Replace Figure 30-3 with the following:

Figure 0-3— DTE System entity relationship diagram

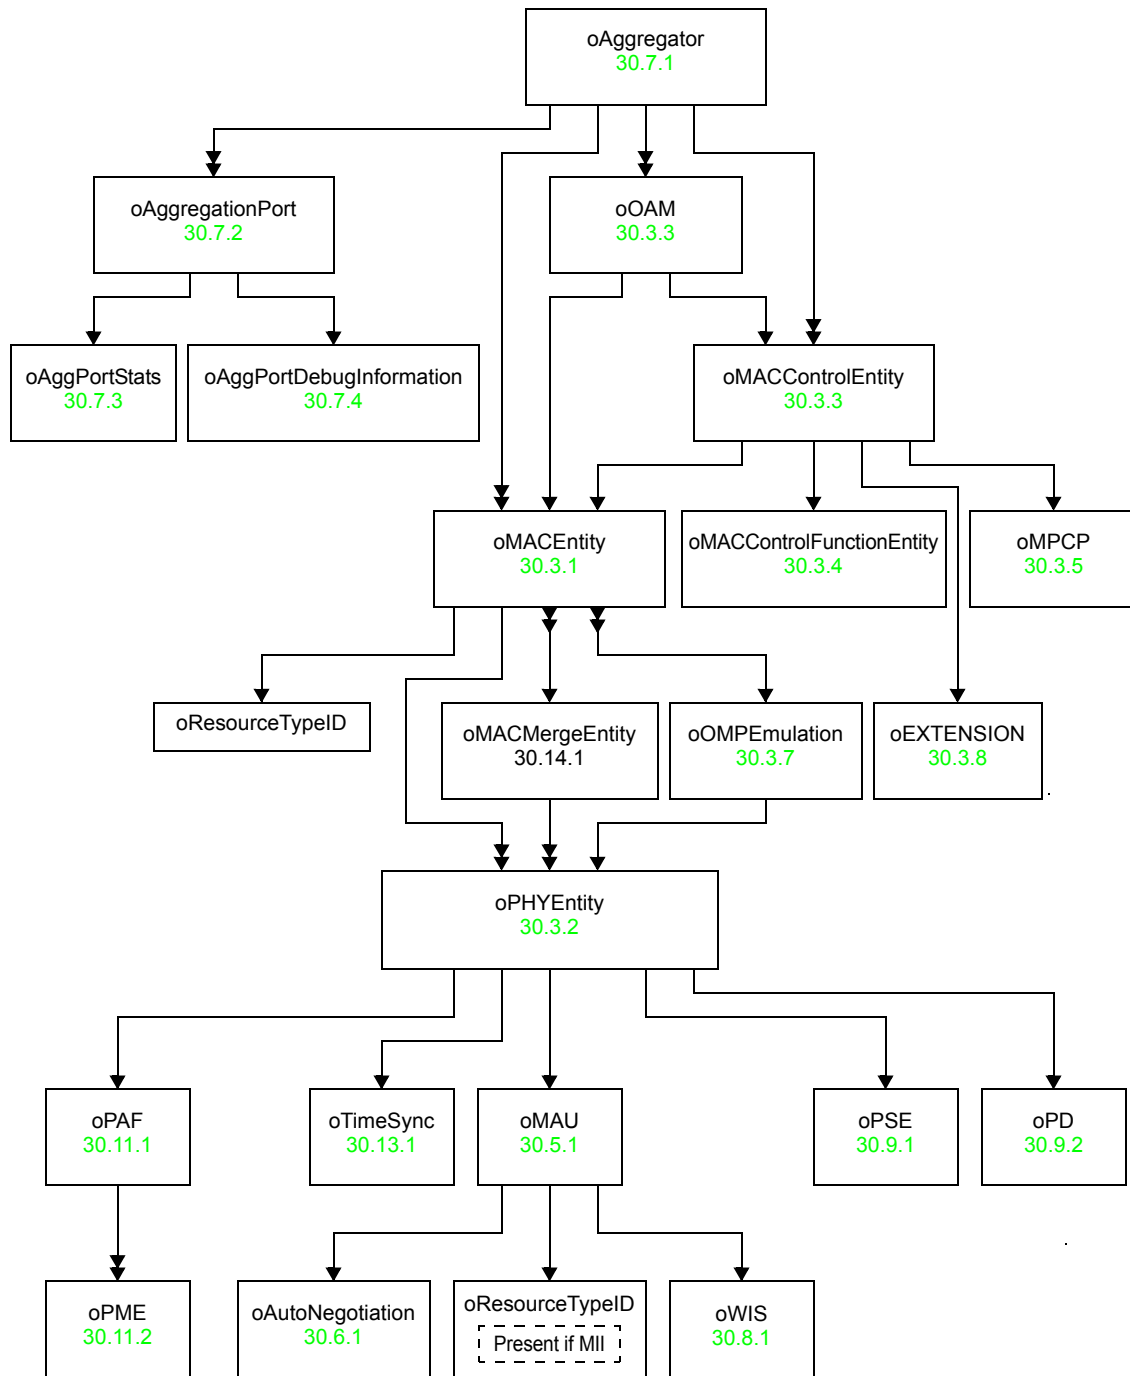
Note—The objects oAggregator, oAggregationPort, oAggPortStats and oAggPortDebugInformation are deprecated by IEEE Std 802.1AX-2008.
